Access Compliance Report

Public Rights-of-Way

Intersection ID: 6937	Main Street: GRAHAM_MEADOW_DR	Cross Street: REAGAN_DR	Location: SW
ADA ID: 101BC332E1FC	Ramp Type: Perp	Initial Pass/Fail: Fail	Overall Compliance: No
Severity Score: 8.75			
Codes/Mitigation Info/Possible Solution		Field Measurements/Component Compliance

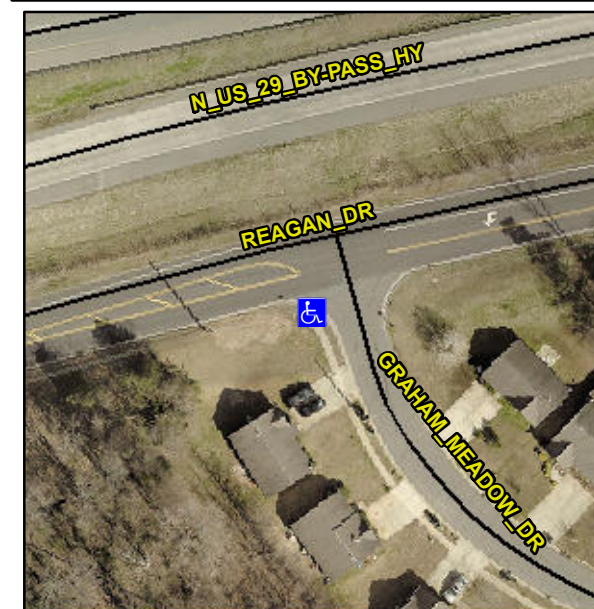
Not Found, R304.5.1

Compliance	Description	Data	Compliance	Description	Data
N/A	Ramp Length (in)	46.0	Yes	Ramp Slope (%)	7.8
No	Ramp Width (in)	46.0	Yes	Ramp XSlope (%)	0.5
N/A	Flare Type LT	N/A	N/A	Flare Type RT	N/A
N/A	Flare Slope LT (%)	N/A	N/A	Flare Slope RT (%)	N/A
N/A	Flare Traversable LT?	N/A	N/A	Flare Traversable RT?	N/A
N/A	Landing Length (in)	N/A	N/A	DWS Provided?	N/A
N/A	Landing Width (in)	N/A	N/A	DWS Contrast?	N/A
N/A	Landing Slope (%)	N/A	N/A	DWS Length (in)	N/A
N/A	Landing X Slope (%)	N/A	N/A	DWS Full Width?	N/A
N/A	Landing Curb? (Y/N)	N/A	N/A	DWS Offset (in)	N/A
N/A	Shared Landing?	N/A			
N/A	Gutter Ponding?	N/A	N/A	Gutter Slope (%)	N/A
N/A	Gutter Lip Ht (in)	N/A	N/A	Gutter X Slope (%)	N/A
N/A	Painted X Walk1?	No	N/A	Painted X Walk2?	N/A
	X Walk 1 Direction	To E		X Walk 2 Direction	N/A
N/A	X Walk 1 Width (in)	N/A	N/A	X Walk 2 Width (in)	N/A
	X Walk 1 Slope (%)	6.1		X Walk 2 Slope (%)	N/A
	X Walk 1 X Slope (%)	0.2		X Walk 2 X Slope (%)	N/A

Remove & Replace Entire Ramp.
